INDIANA DEPARTMENT OF TRANSPORTATION

APPROVED MINUTES

February 16, 2012 Standards Committee Meeting
(The changes made to the Final Draft Minutes
are shown highlighted in yellow)

RE: Minutes from the February 16, 2012 Standards Committee Meeting

Indiana Design Manual
Figure ~~61-6B404-4B~~

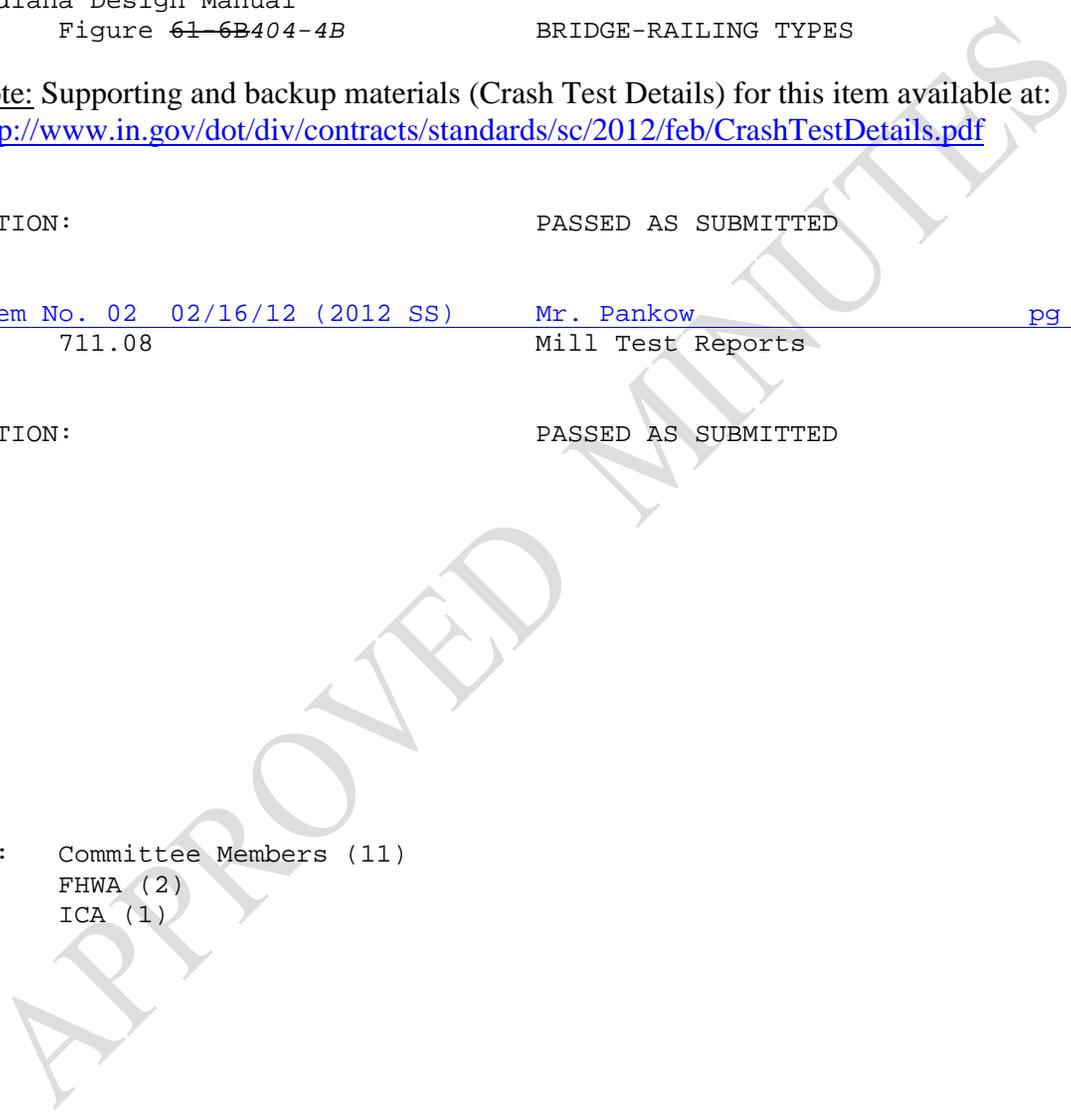
PROBLEM(S) ENCOUNTERED: In reviewing the bridge rail design materials covered in the Indiana Design Manual chapter 404, figure 404-4B incorrectly identifies the CF-1 rail as a TL-4, The height of the rail was given as 2'-11" instead of the value of 3'-3/4" as shown in the Standard. The PF-1 rail height is given as 4'-2". The value shown in the Standard is 3'-6".

PROPOSED SOLUTION: The Indiana Design Manual Figure 404-4B has been revised. The Bridge Standards listed here are proposed with revisions as noted.

INDIANA DEPARTMENT OF TRANSPORTATION	
BRIDGE RAILING TYPE FC	
SEPTEMBER 2009	
STANDARD DRAWING NO.	E 706-BCBR-01
	<i>/s/ Richard L. VanCleave</i> 09/01/09 DESIGN STANDARDS ENGINEER DATE
	<i>/s/ Mark A. Miller</i> 09/01/09 CHIEF HIGHWAY ENGINEER DATE
DESIGN STANDARDS ENGINEER

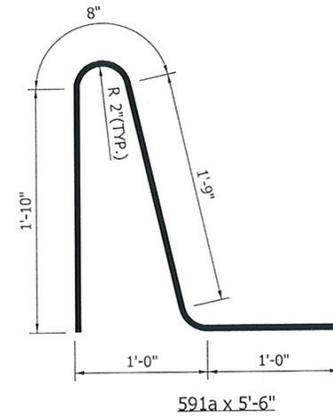
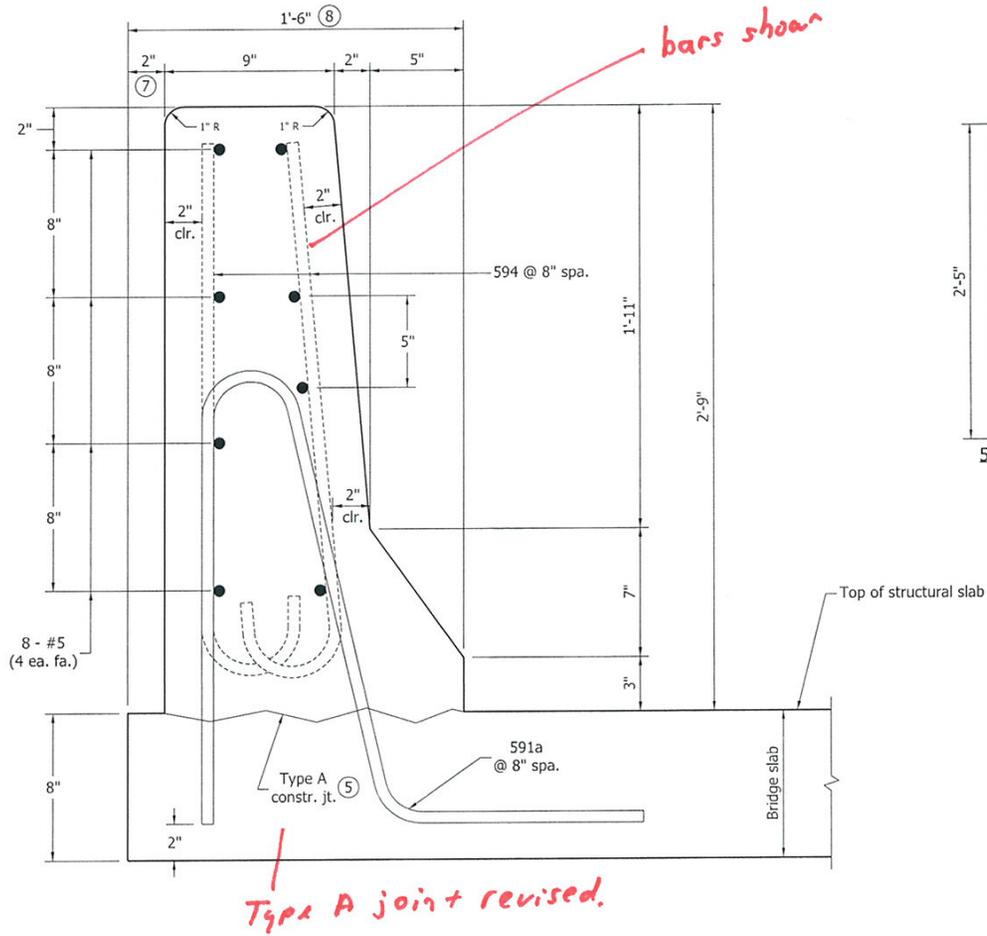
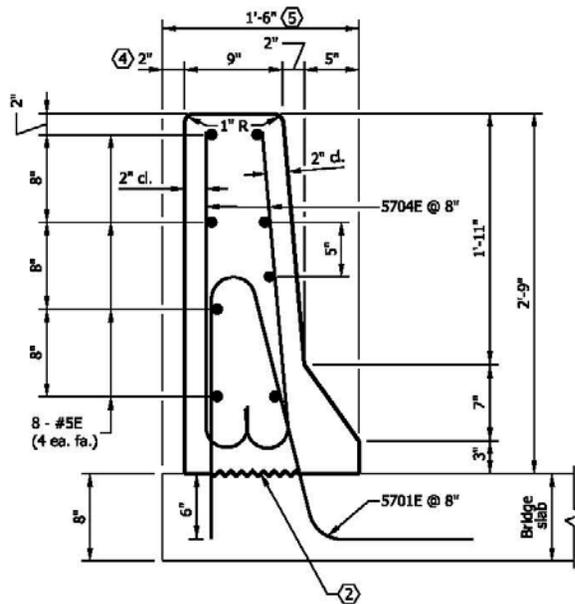
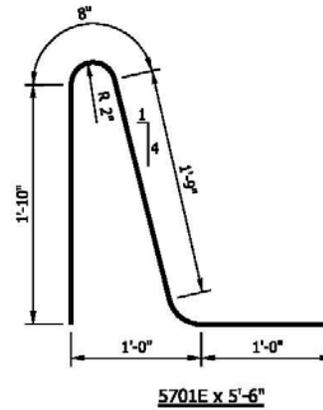
Notes revised.

Type A joint revised.

REVISED 706-BCBRBSF-01 BRIDGE RAILING TYPE FC (DRAFT)

EXISTING 706-BCBR-02 BRIDGE RAILING TYPE FT (WITH MARKUPS)

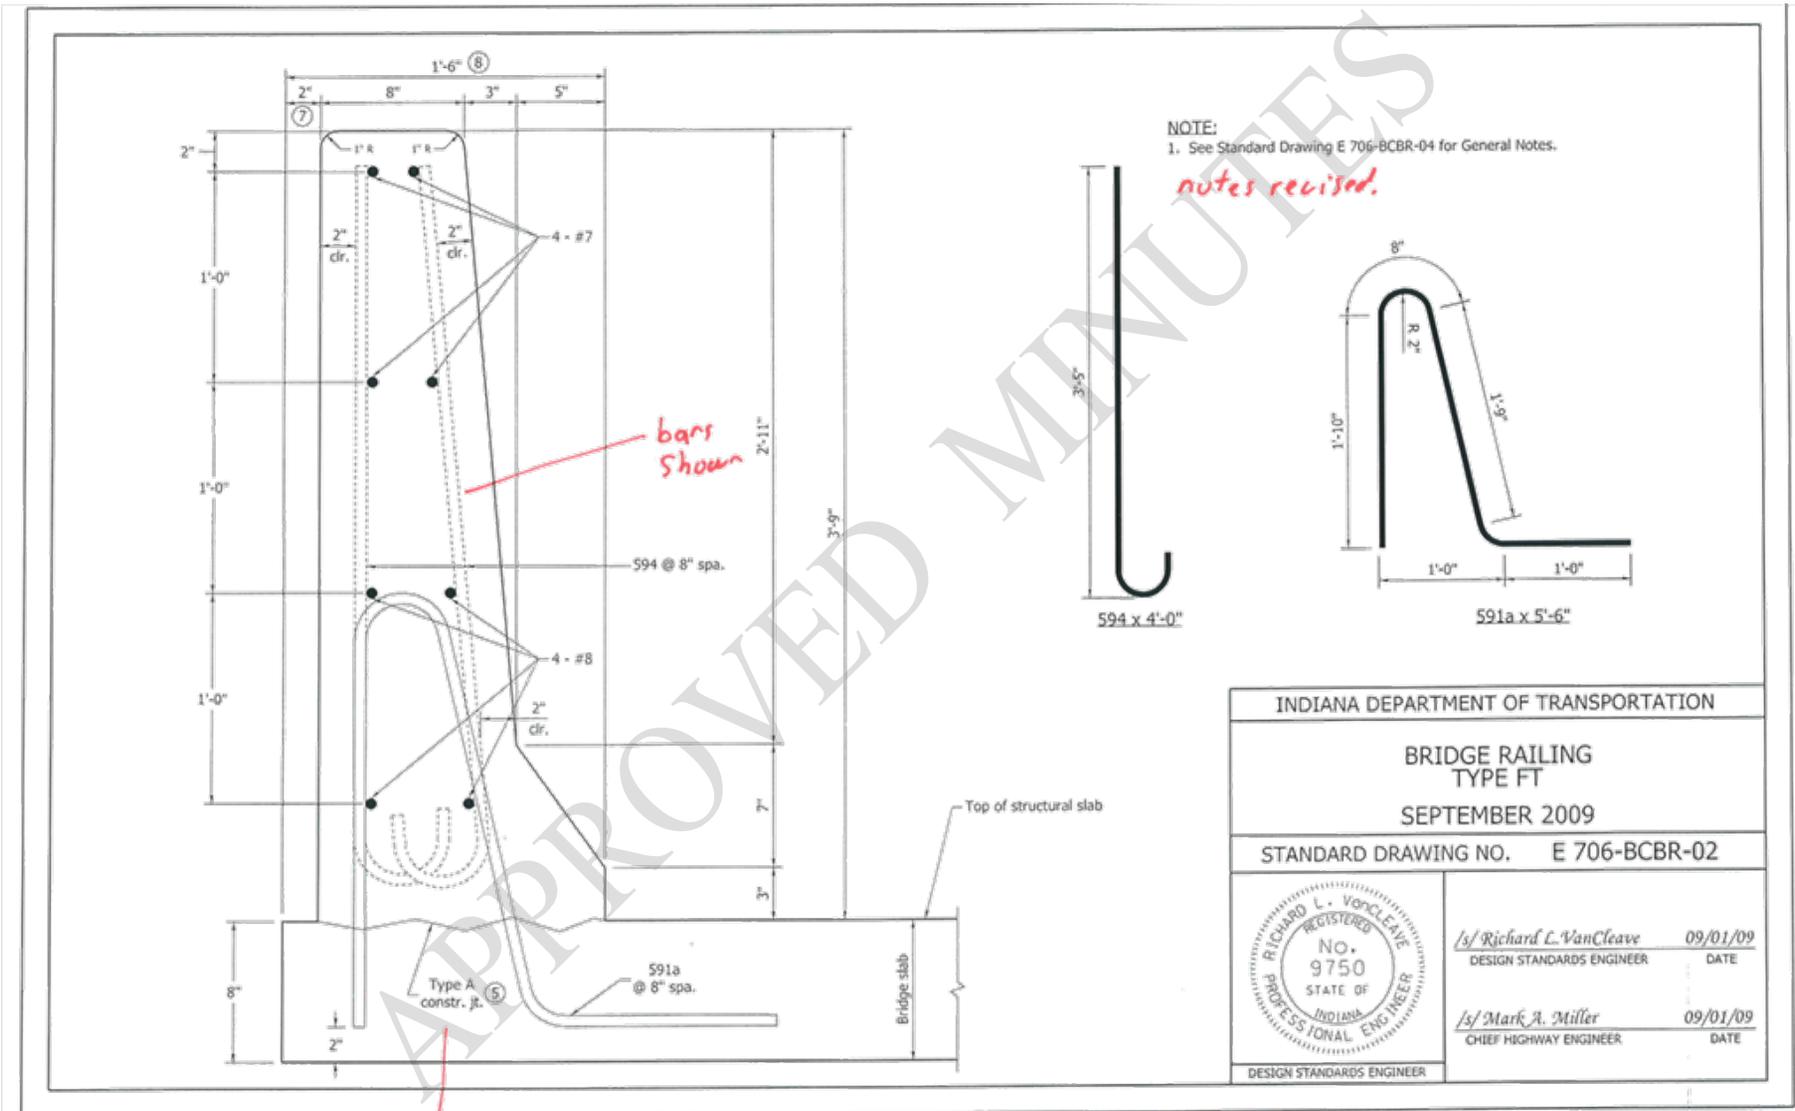
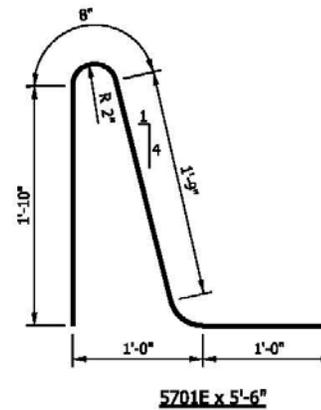
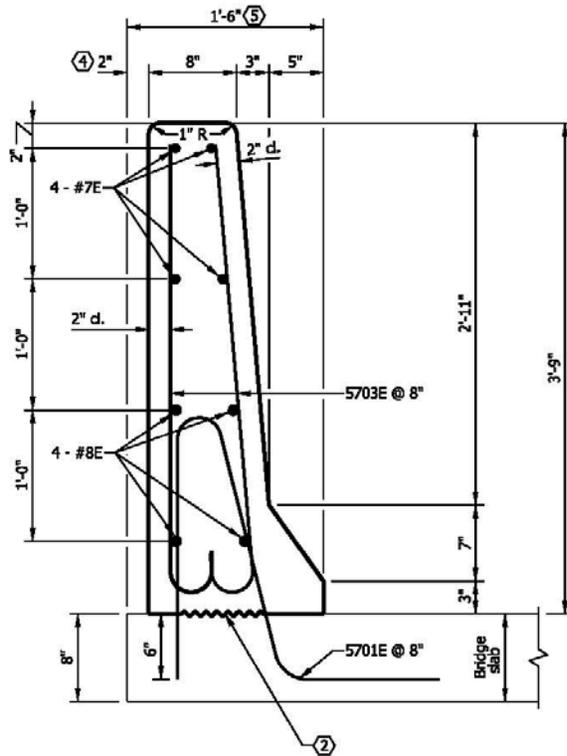
Type A joint revised.

REVISED 706-BCBRBSF-02 BRIDGE RAILING TYPE FT (DRAFT)

EXISTING 706-BRPP-01 RAILING, PF-1 (WITH MARKUPS)

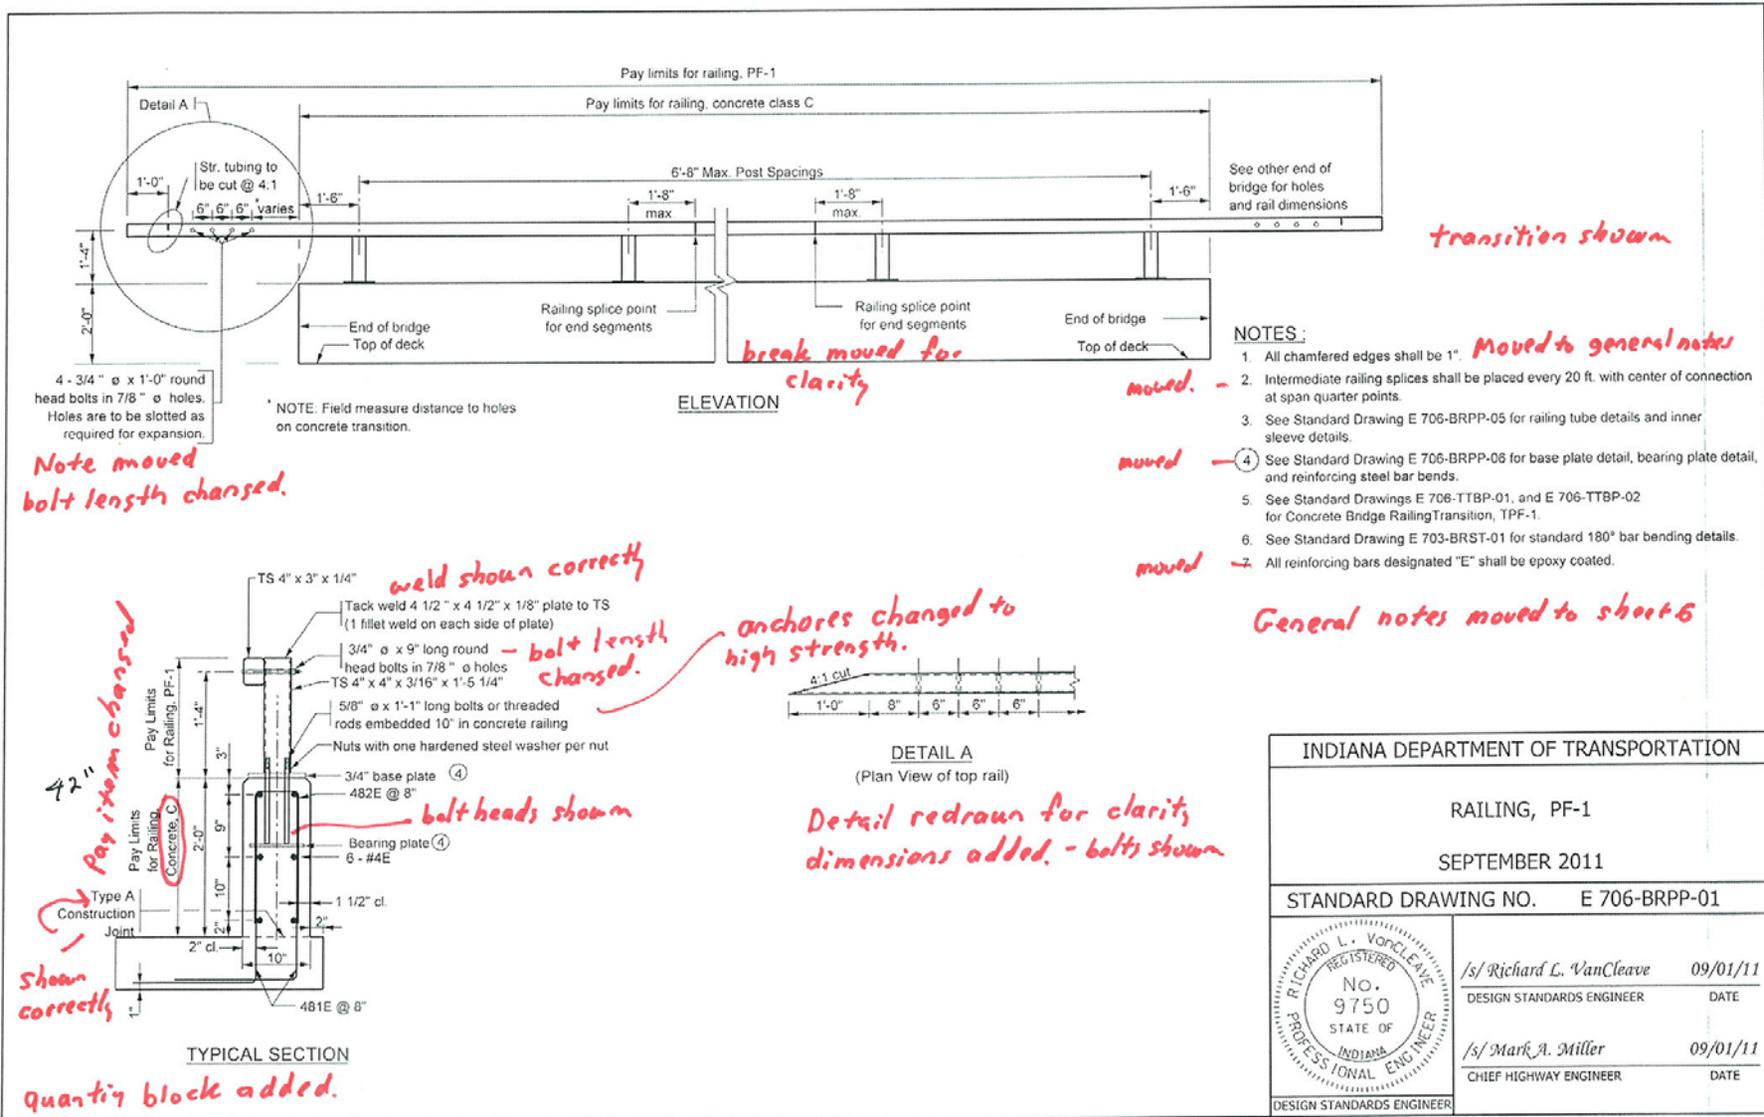
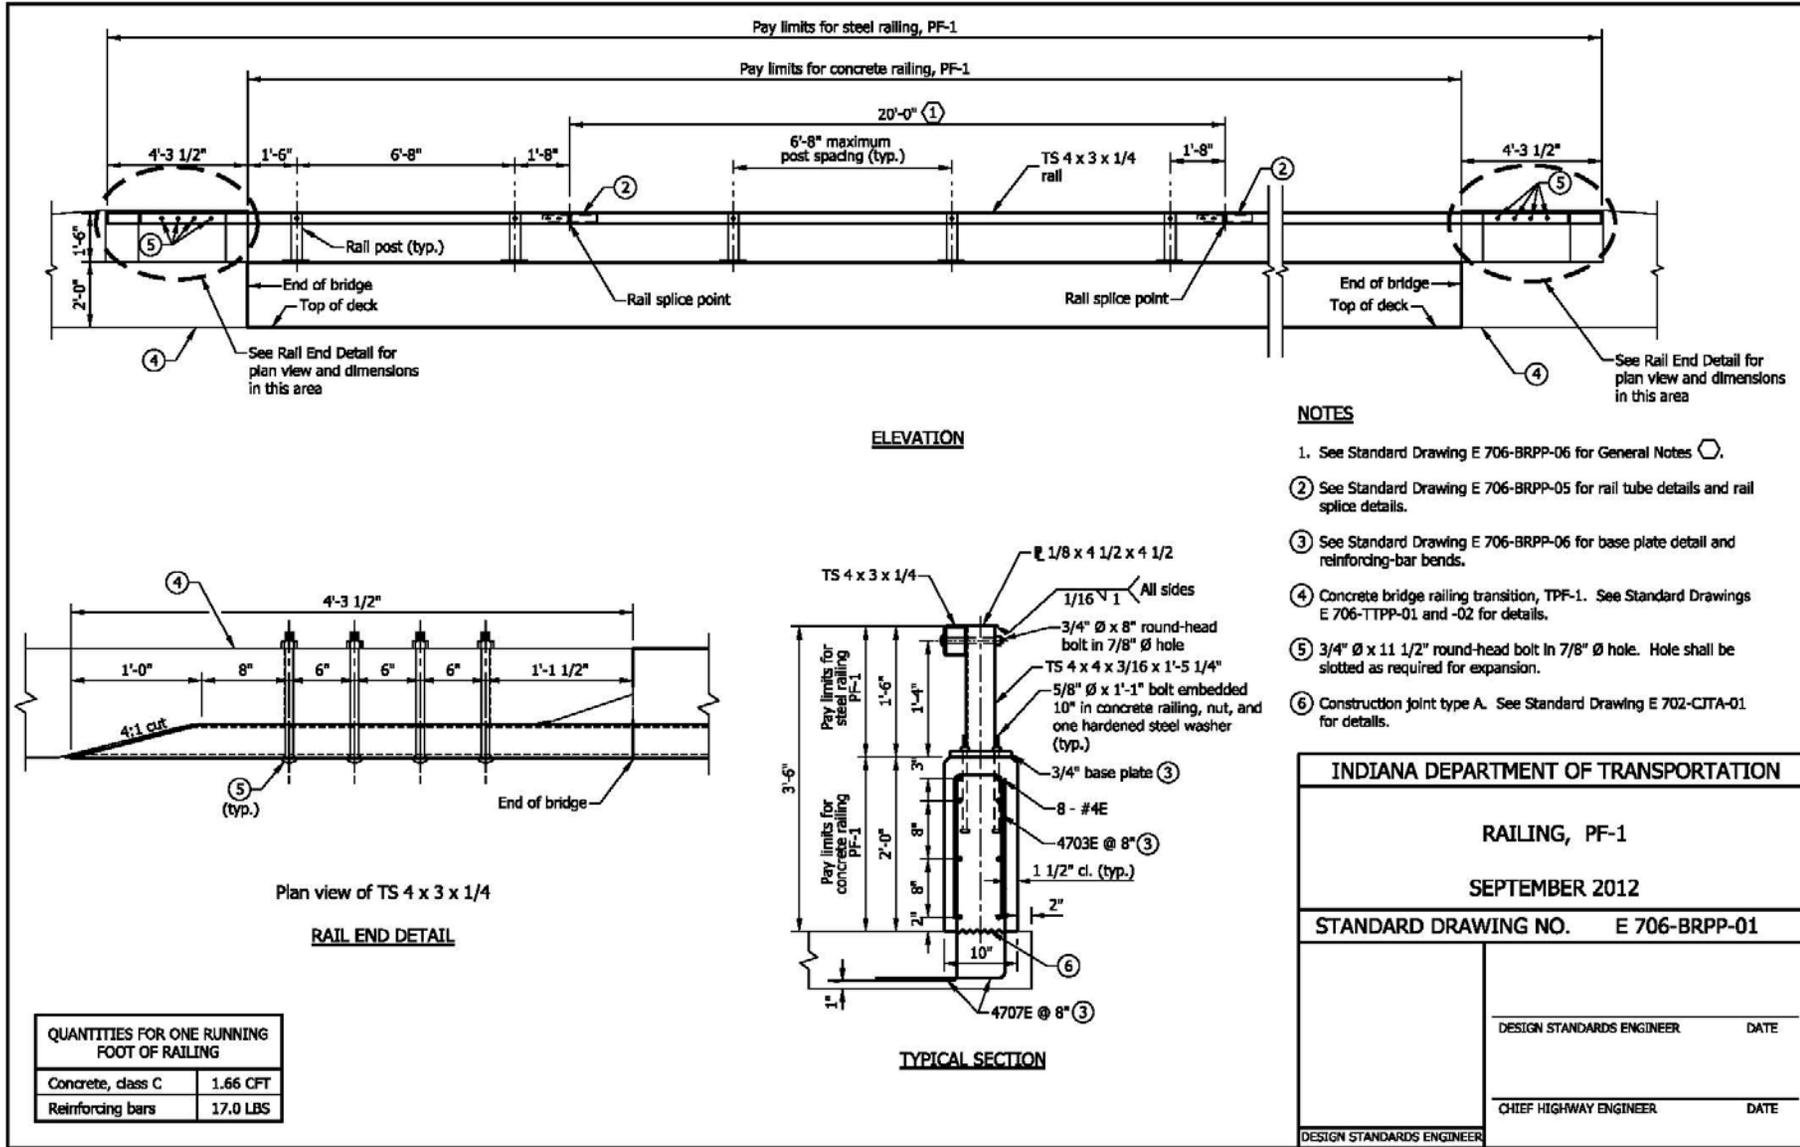
Design Manual lists this as a 4'-2" rail. *This is a Tk-9 railing*

REVISED 706-BRPP-01 RAILING, PF-1 (DRAFT)
